DRP ADVICE 7.1

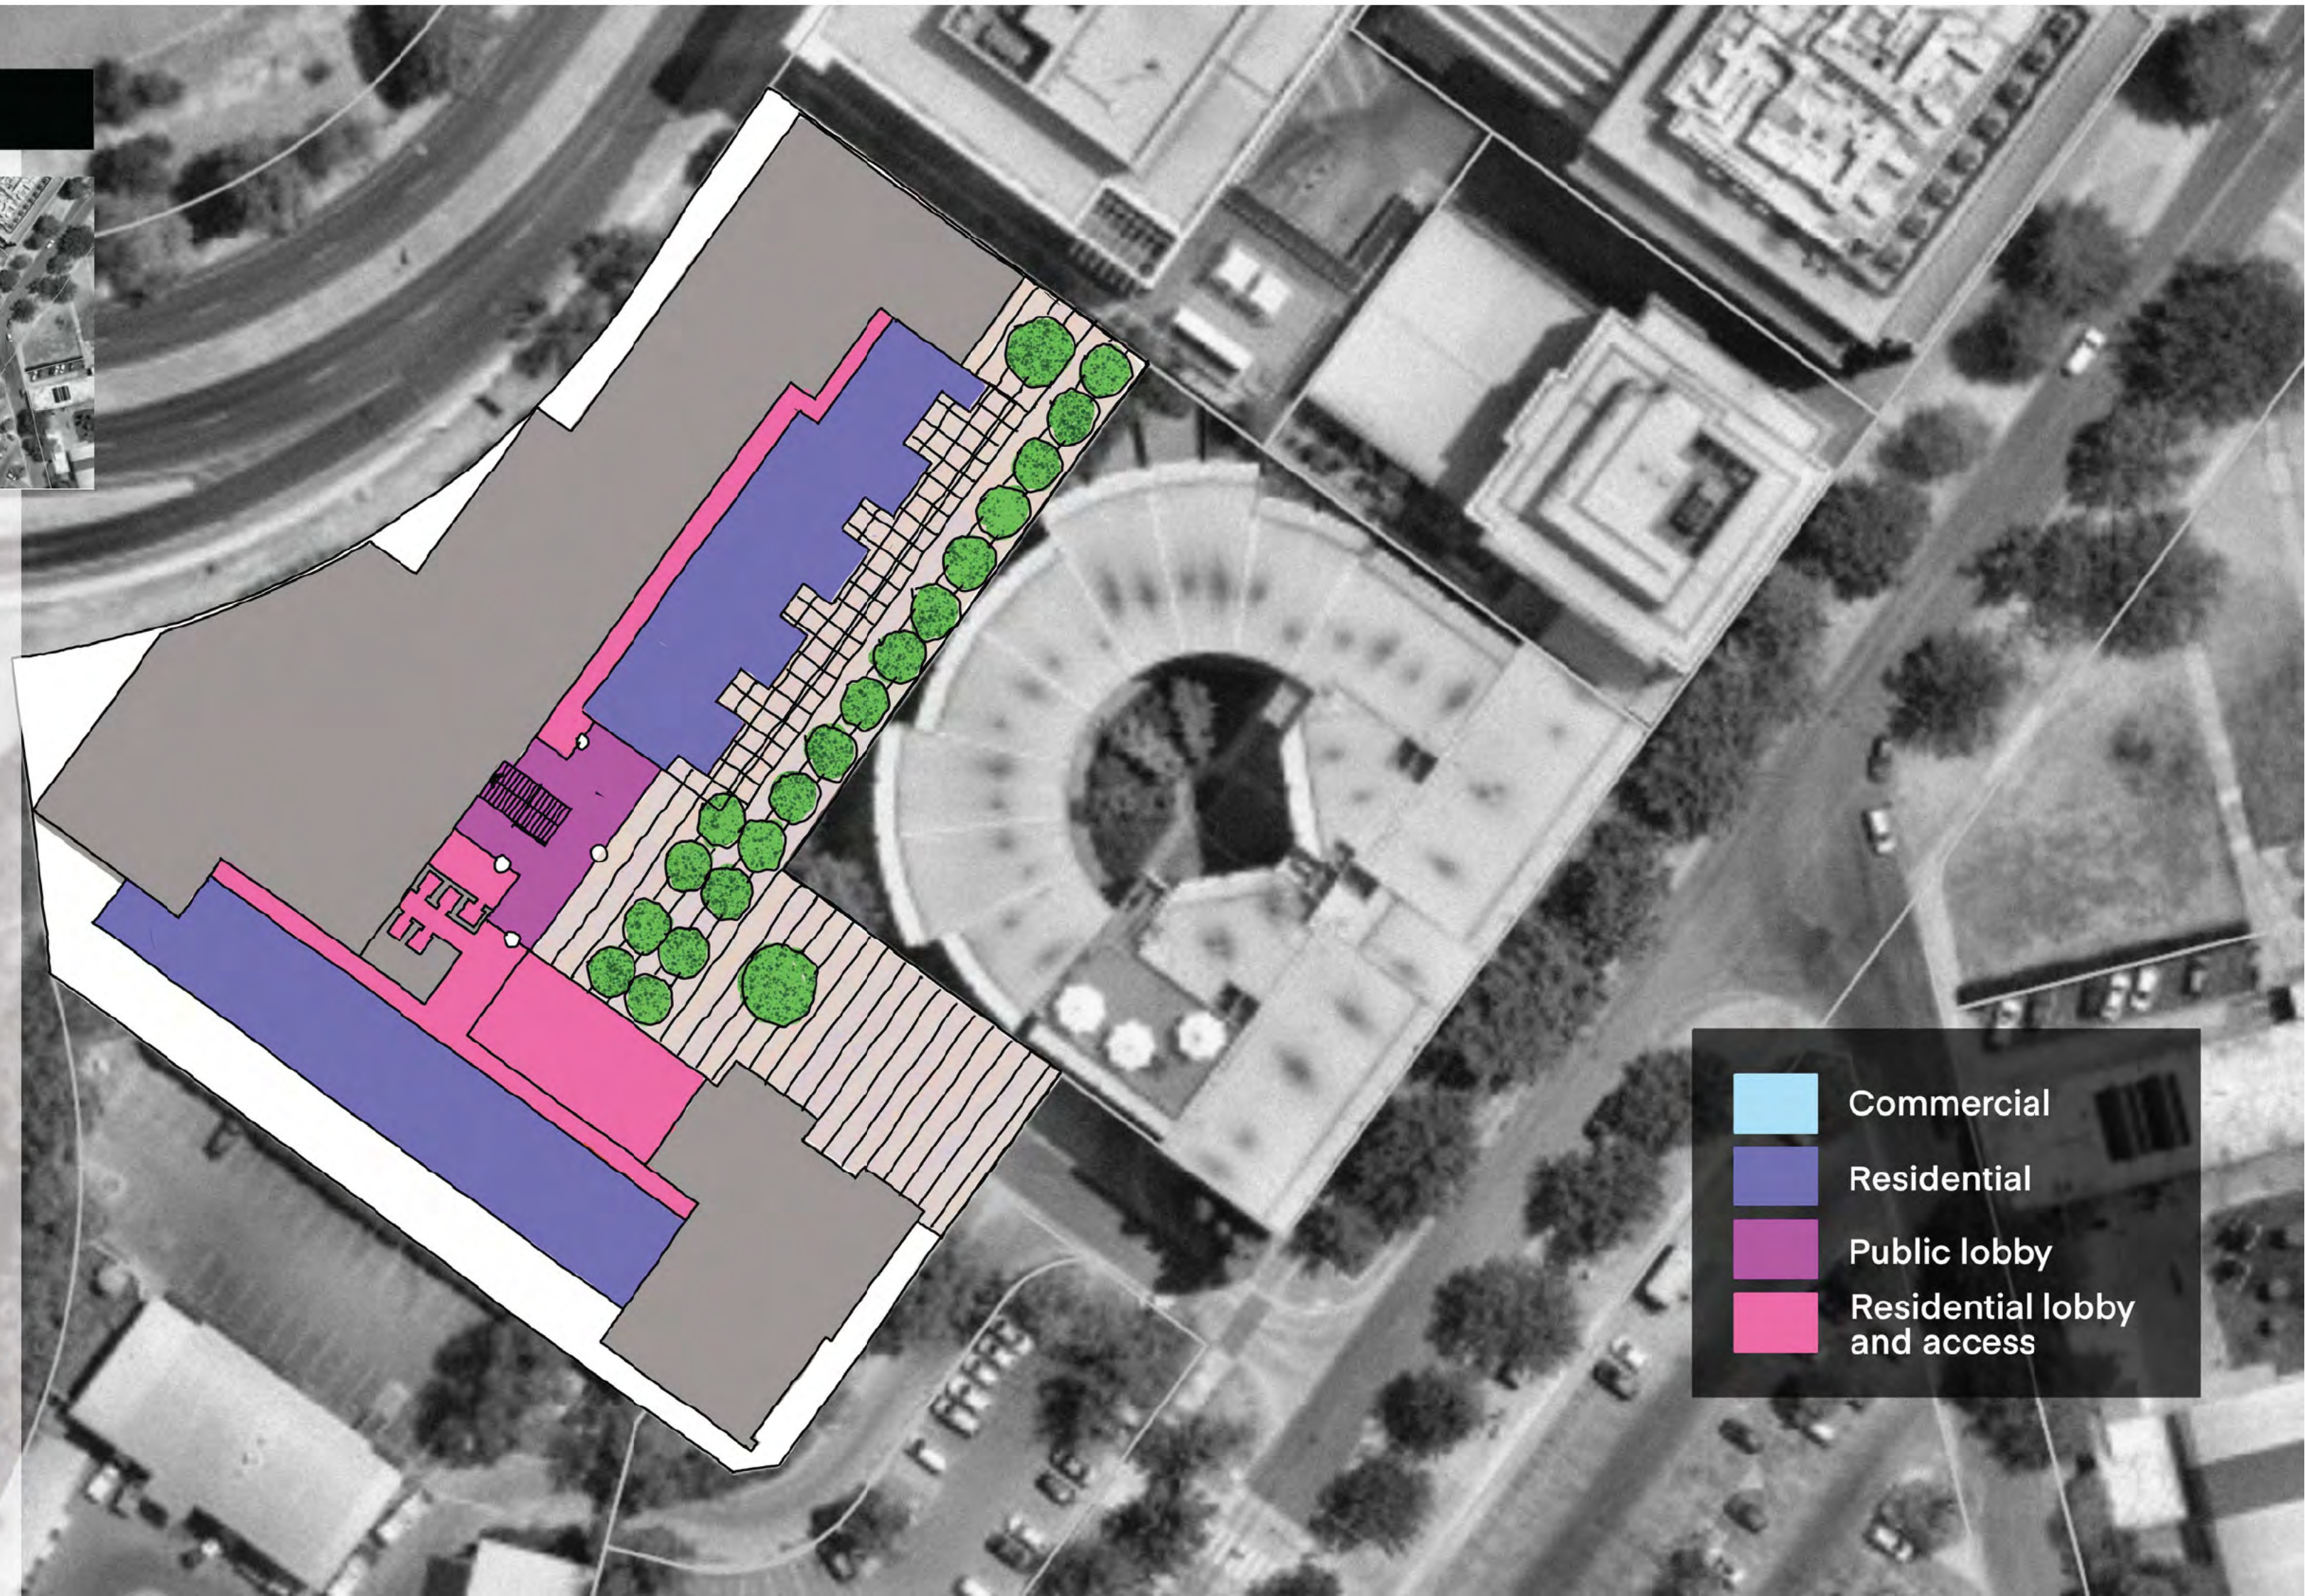
The Panel considers the location of the waste enclosure and service zones at the entry of the drop-off courtyard at Allara Street requires reconsideration to create a comfortable, active frontage and facilitate the creation of a safe environment for future users and pedestrians. Noting the size and extent of the proposed basement, the proponent is encouraged by the Panel to explore opportunities to embed these zones within the development to provide a more attractive shared space. **The Panel also recommends consideration be given by the proponent towards opportunities to redistribute bulk and scale of the apartment building form away from the narrow entry to provide increased amenity.**

DRP ADVICE 7.1

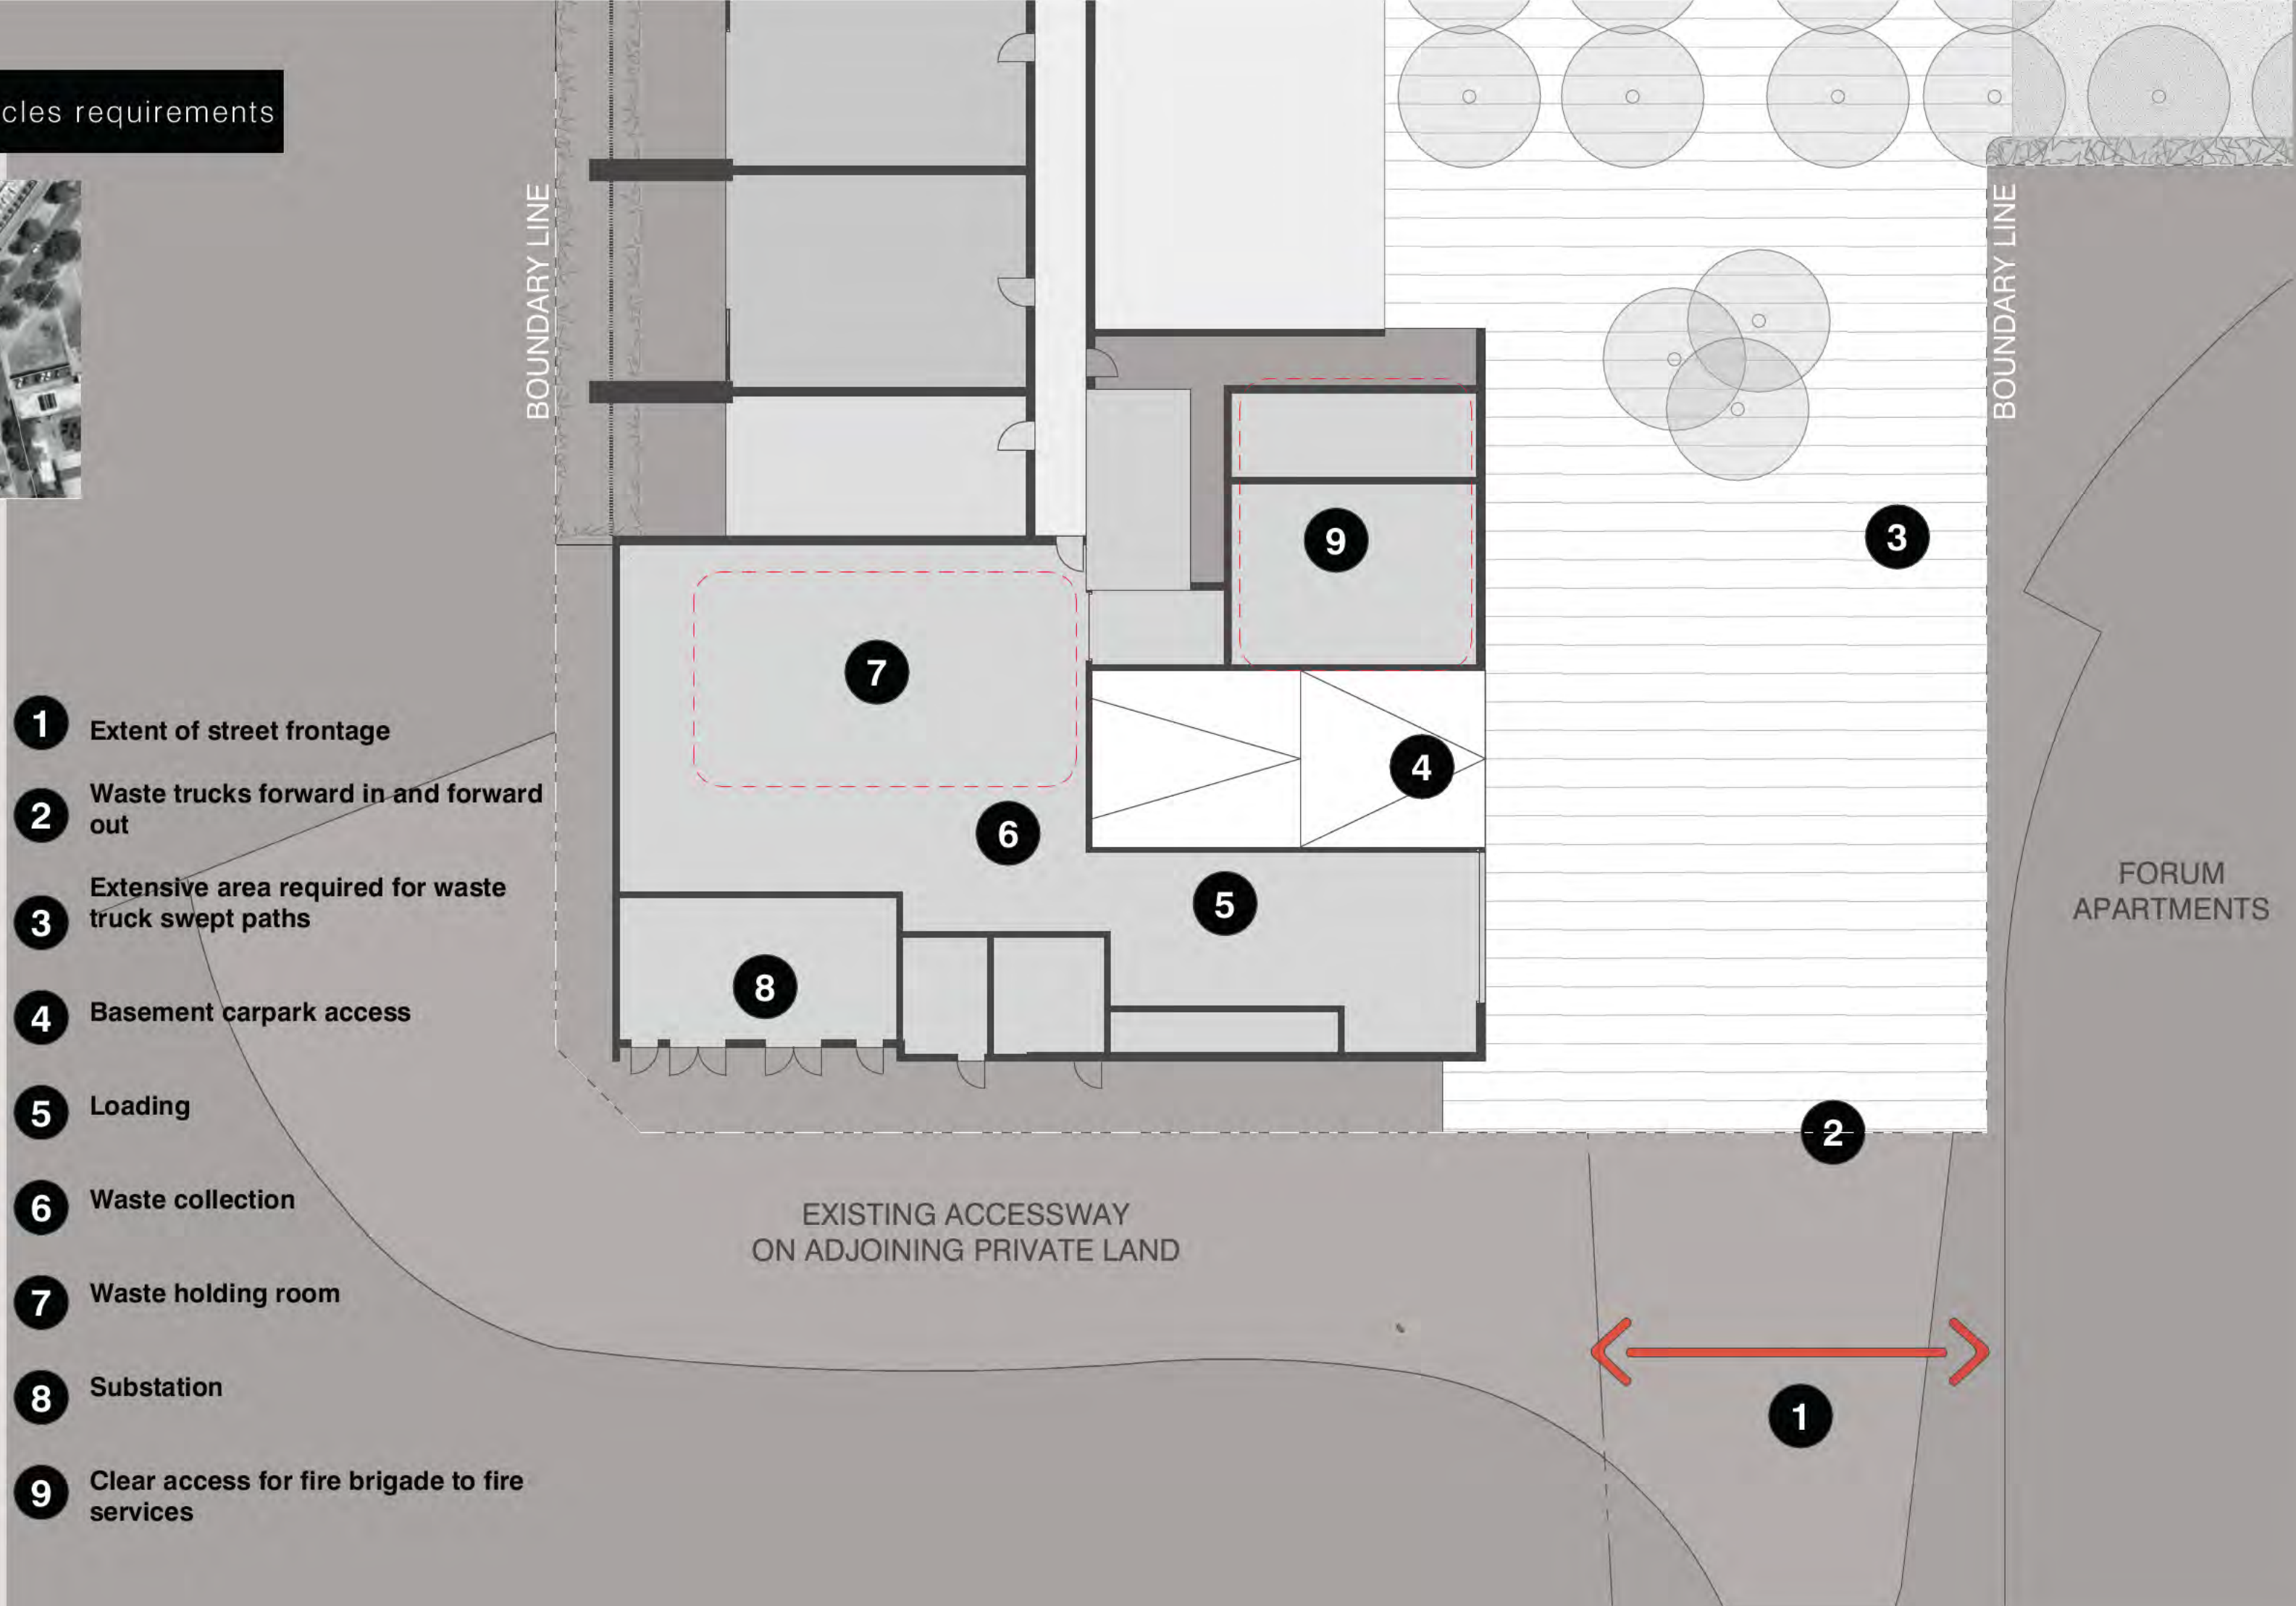
The Panel considers the location of the waste enclosure and service zones at the entry of the drop-off courtyard at Allara Street requires reconsideration to create a comfortable, active frontage and facilitate the creation of a safe environment for future users and pedestrians. Noting the size and extent of the proposed basement, the proponent is encouraged by the Panel to explore opportunities to embed these zones within the development to provide a more attractive shared space. The Panel also recommends consideration be given by the proponent towards opportunities to redistribute bulk and scale of the apartment building form away from the narrow entry to provide increased amenity.
